Jackson Town Council Regular Meeting

April 17, 2023

P22-253 Development Plan for 245 and 265 N. Millward St. – Continued. Paul Anthony, Katelyn Page, and Brian Lenz made staff comment. Adam Janak, Hans Flinch, Patrick Woodward, and Josh Kilpatrick made applicant comment. Rose Robertson, Kimberly Kernan, Matt Gaffney, Stuart Suna, John Bickner, Diana Welch, Matt Bambach, and Eugenie Copp made public comment. Council asked questions of staff. A motion was made by Arne Jorgensen and seconded by Jessica Sell Chambers to continue P22-253 to the regularly scheduled Town Council meeting on April 17, 2023. Mayor Morton Levinson called for the vote. The vote showed all in favor. The motion carried.

A2.00

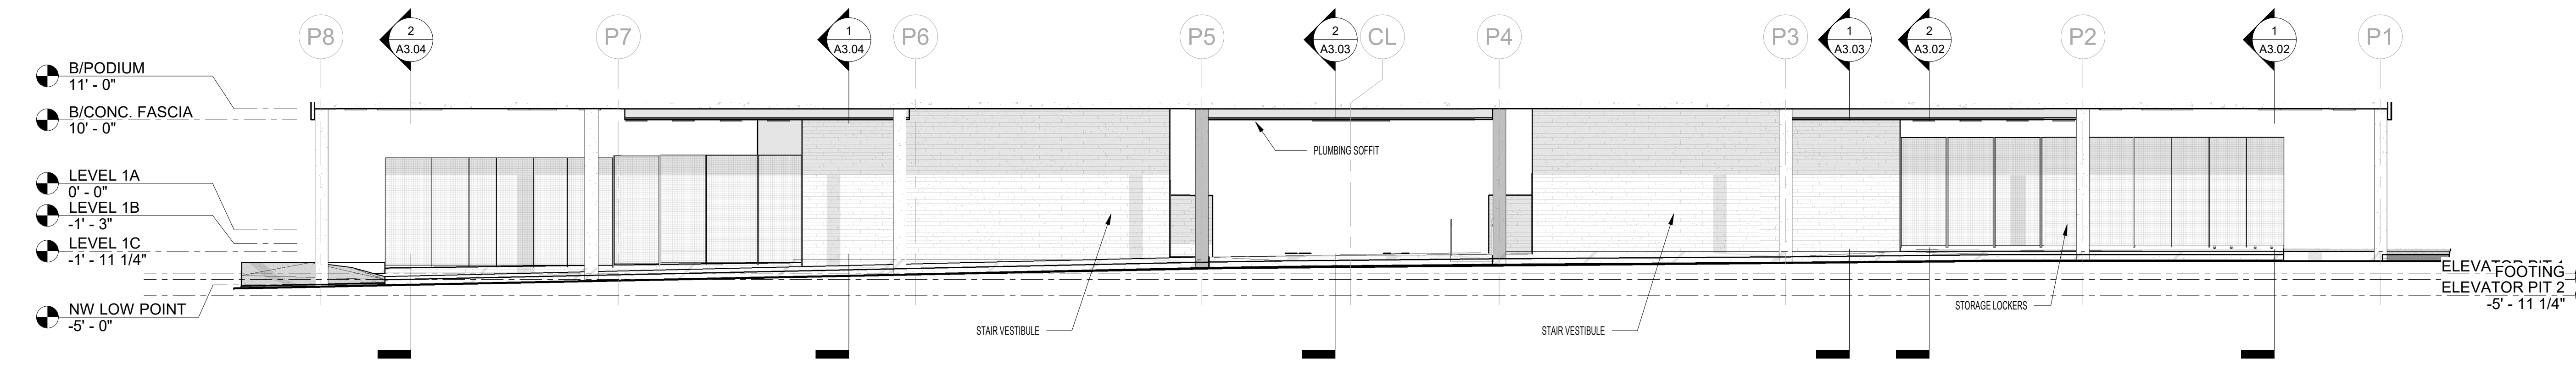
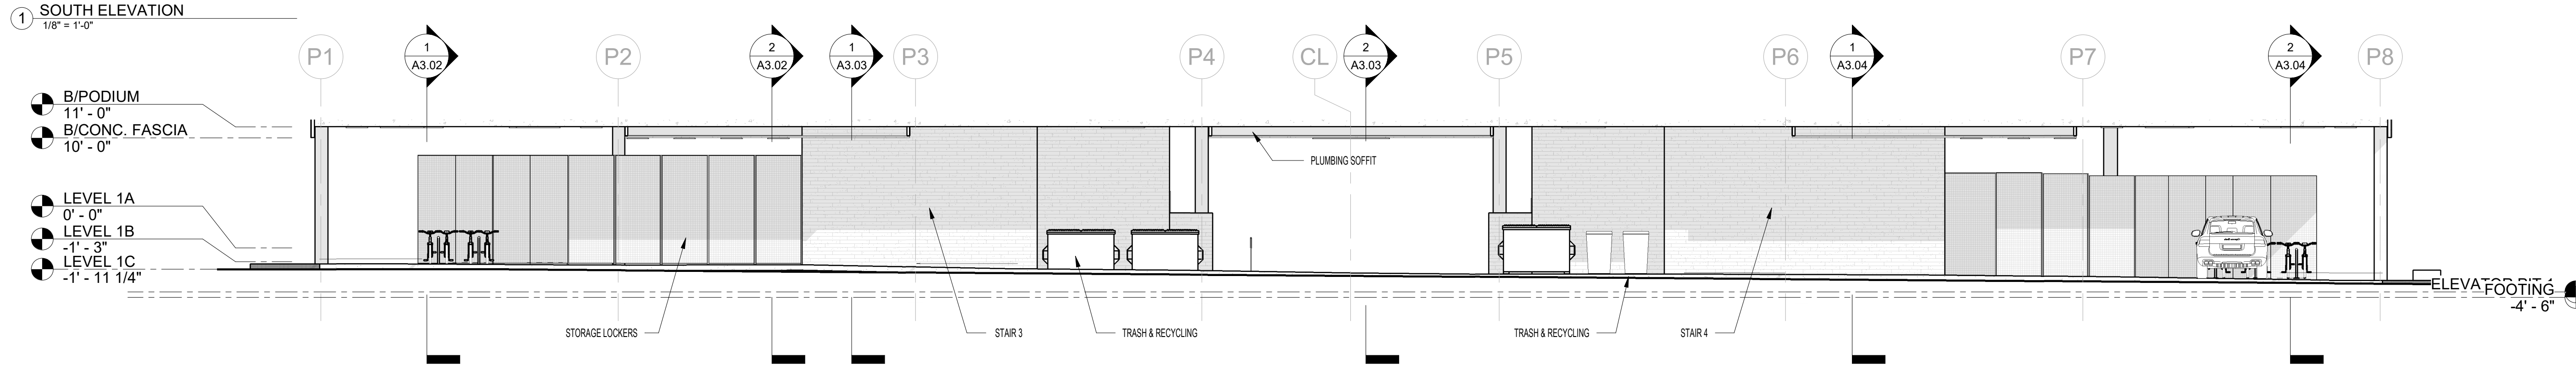
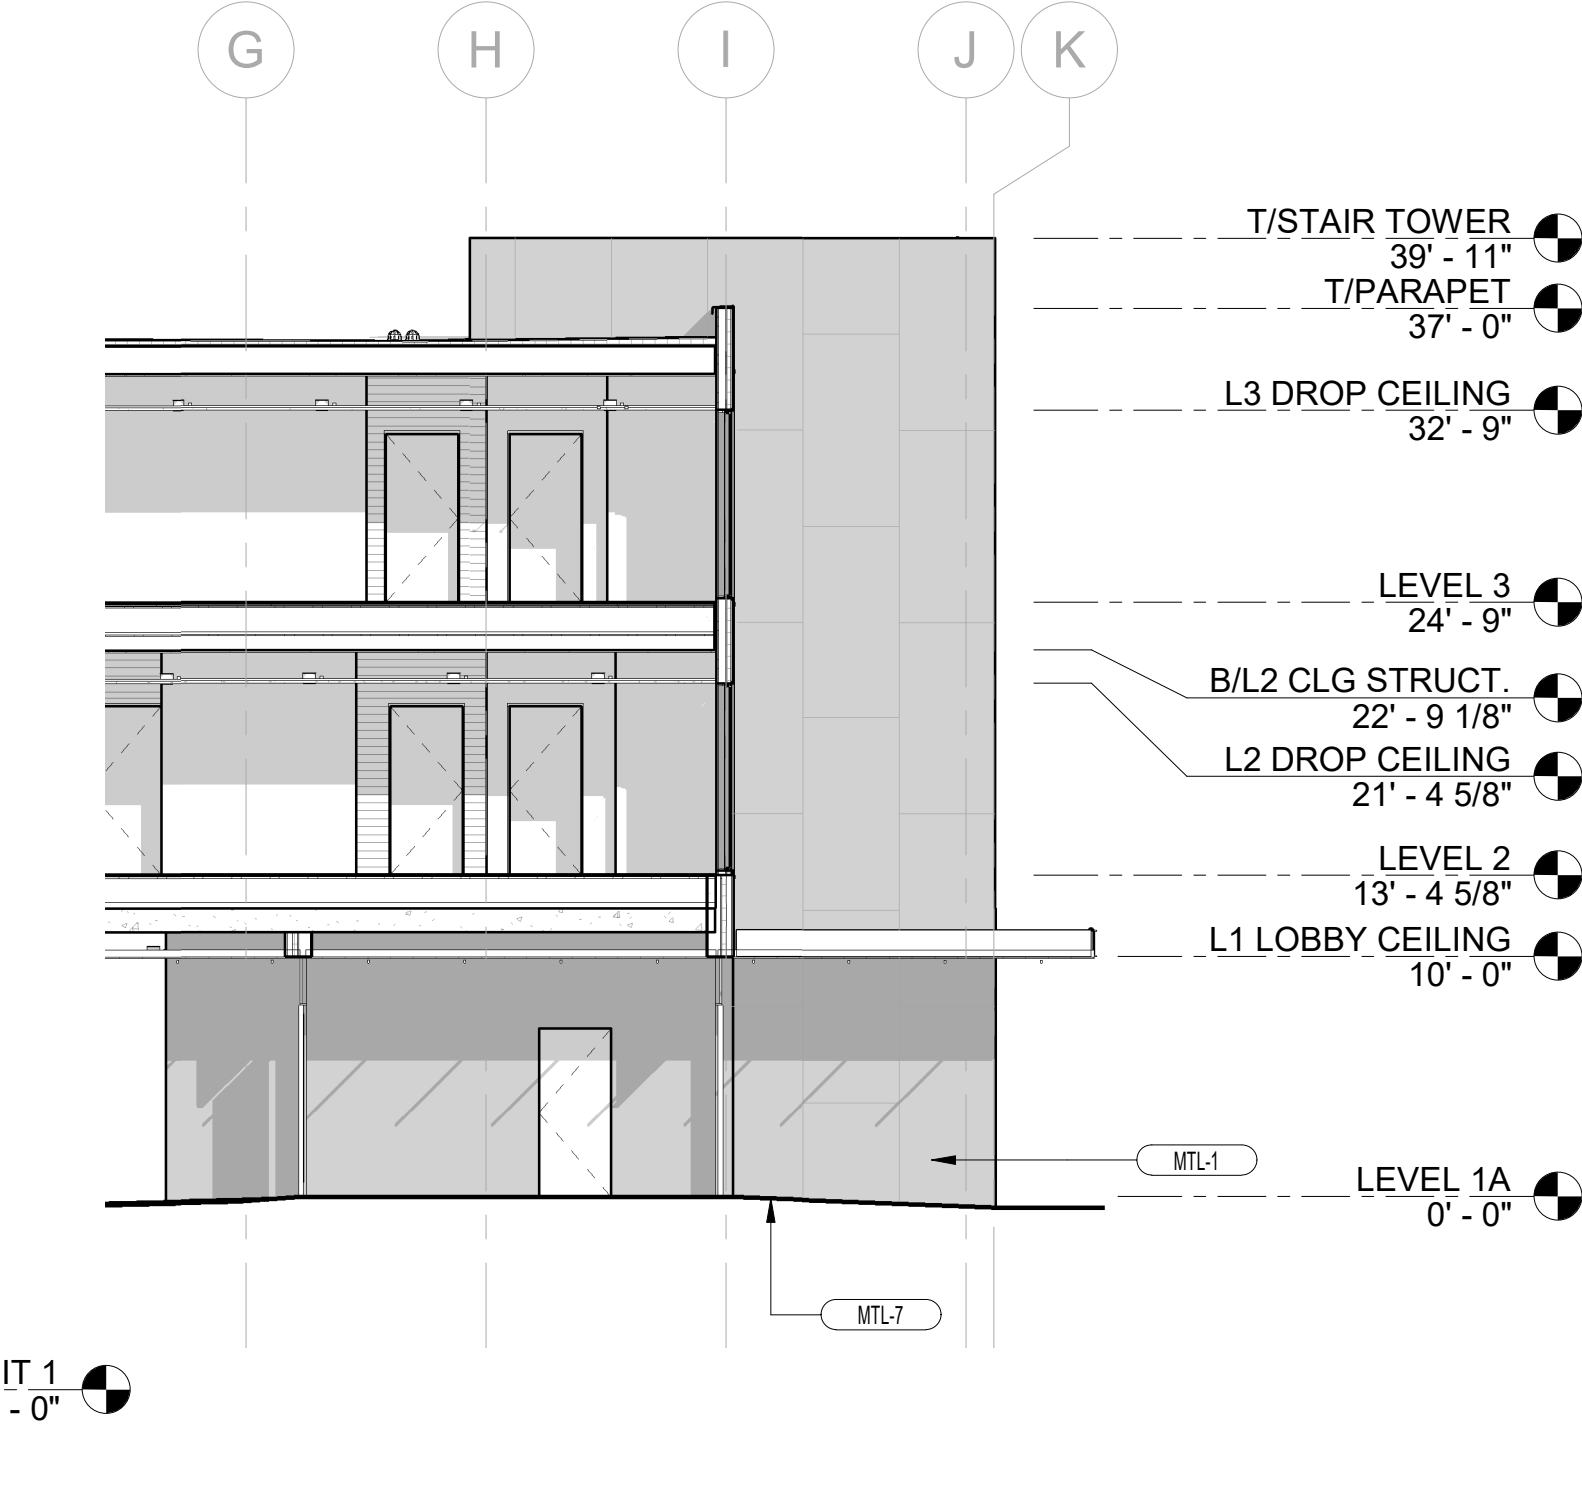
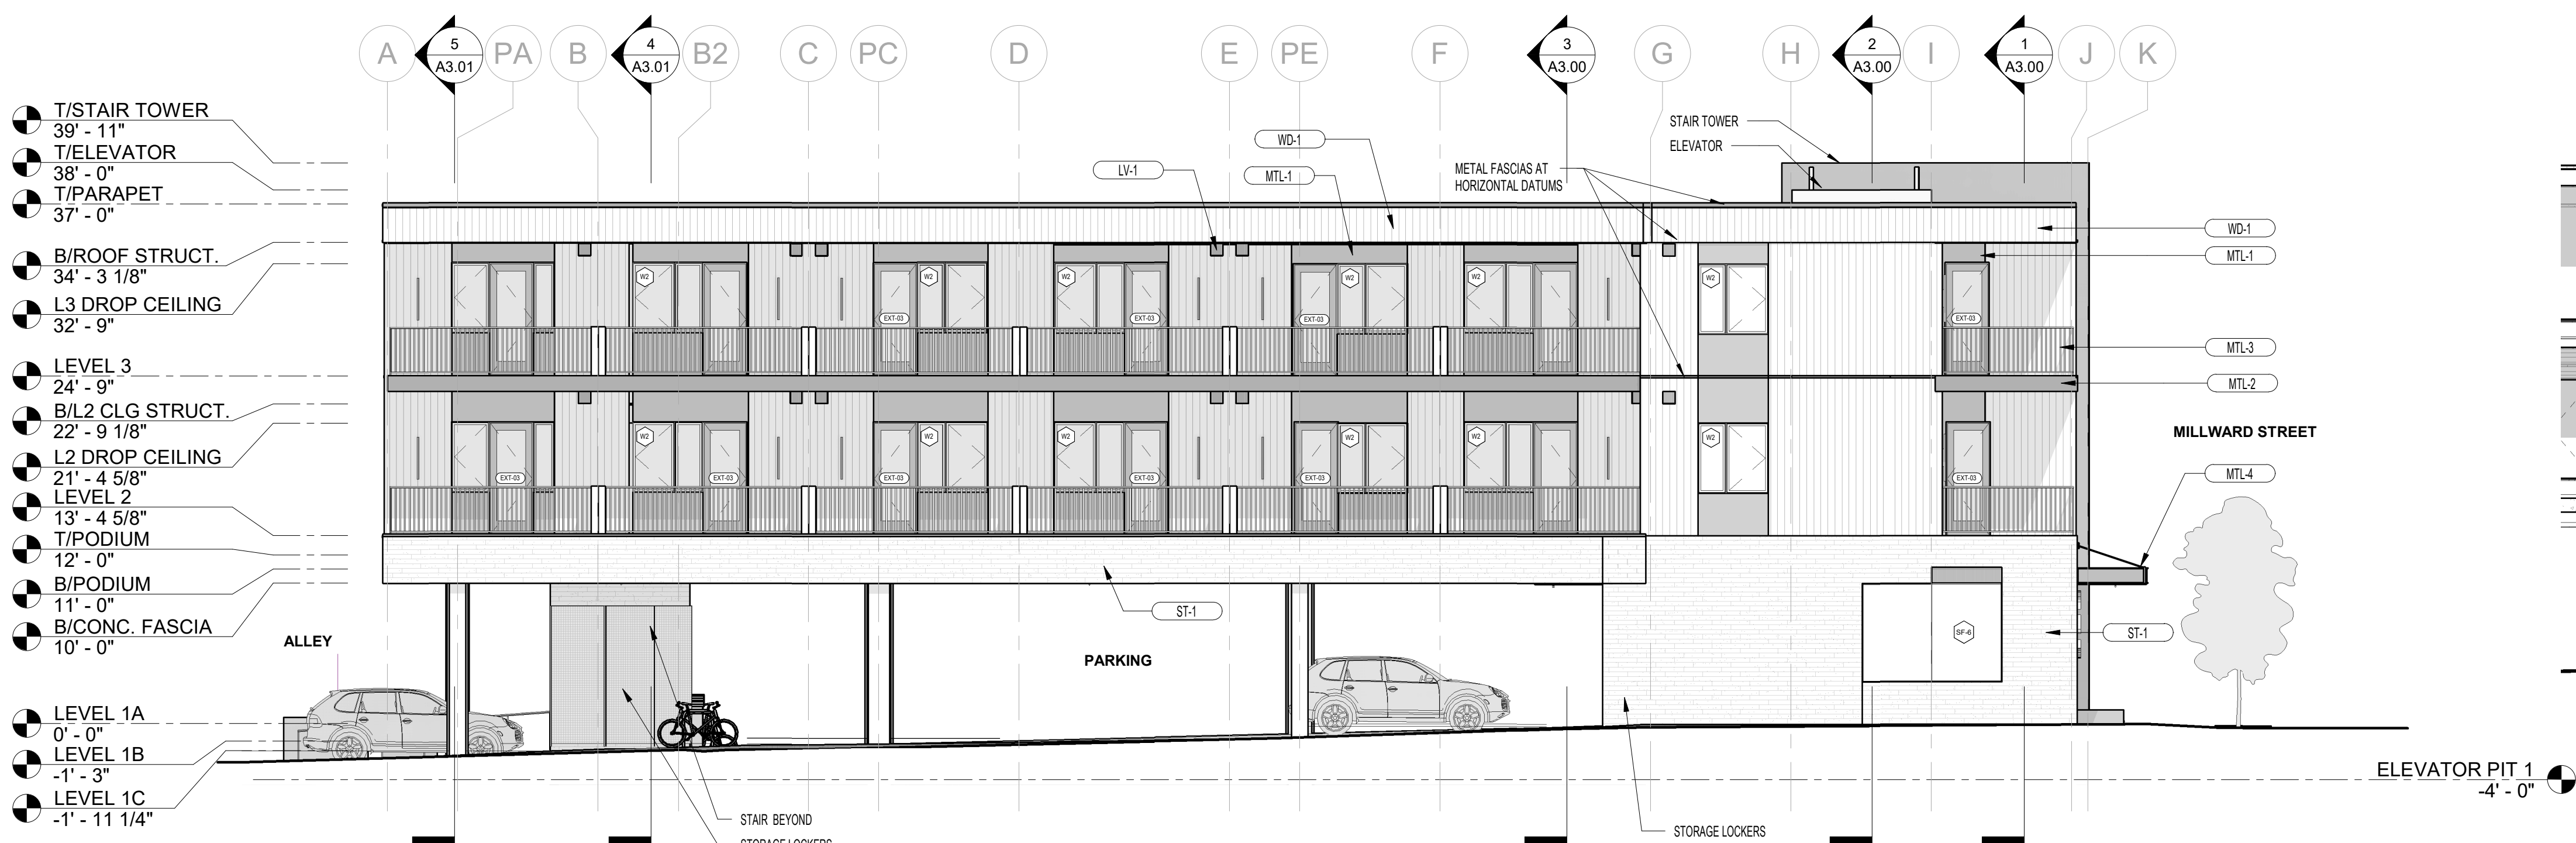
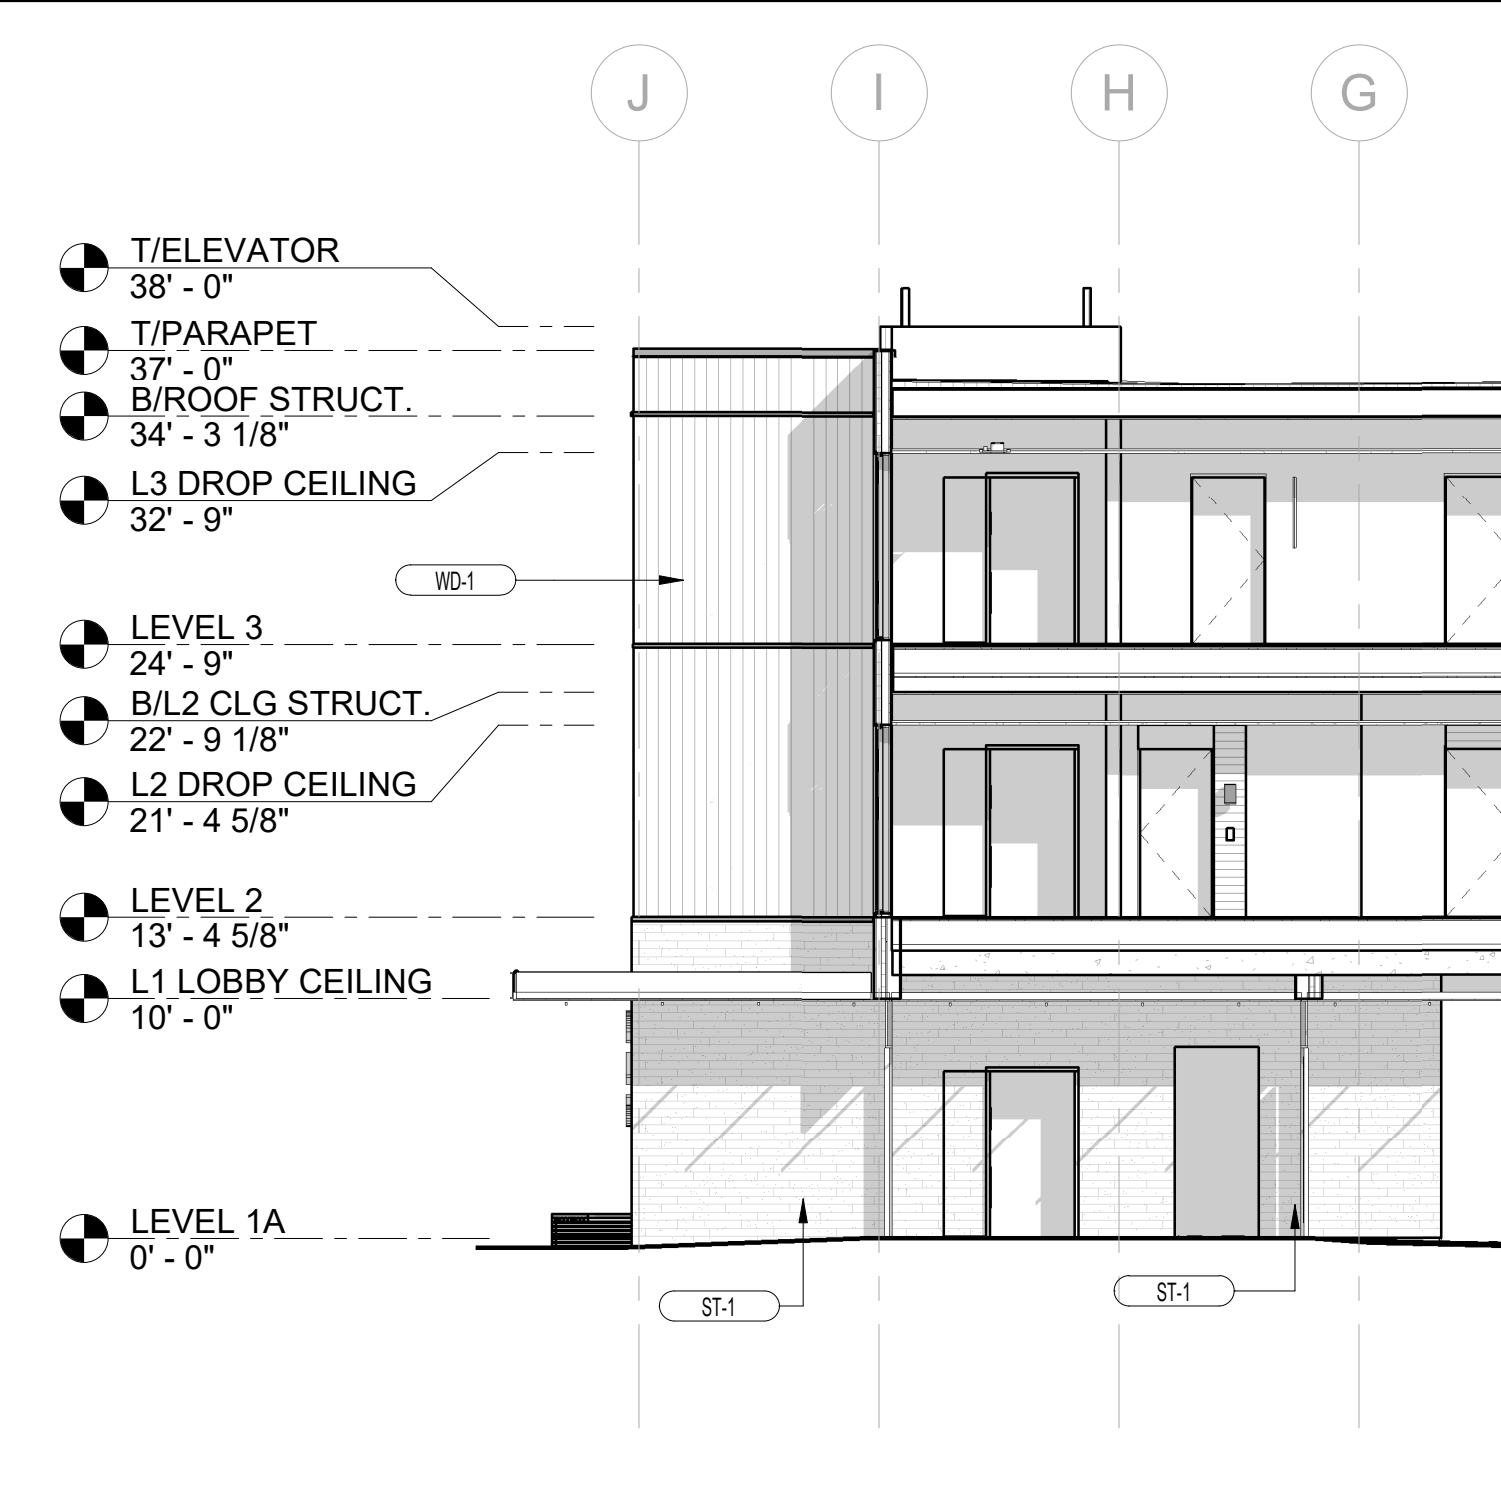
- Building Frontage (Shopfront vs. Office Frontage). Revise LDR compliance table to select only one (it is not tied to use) and to list subcategory compliance, specifically story height, transparency, blank walls, ped access. Revise elevations and floor plans to call out subcategory compliance (for frontage type) such as transparency requirements. May be similar to applicant providing stepback calcs on pg 37 of submittal packet. **Updated in LDR Compliance table and in architectural plans and elevations. See A2.00 for façade calculations.**

- P.51-54 – **Unit Mix overview was updated.**
Color coding of deed-restricted units changed. Reduced plan to 48 units total.
- P.55-57 (A2.00-A2.02) – **Bulk reduced at alley elevation.**
Overhangs eliminated at corridors; central balcony pushed back and its roof eliminated.
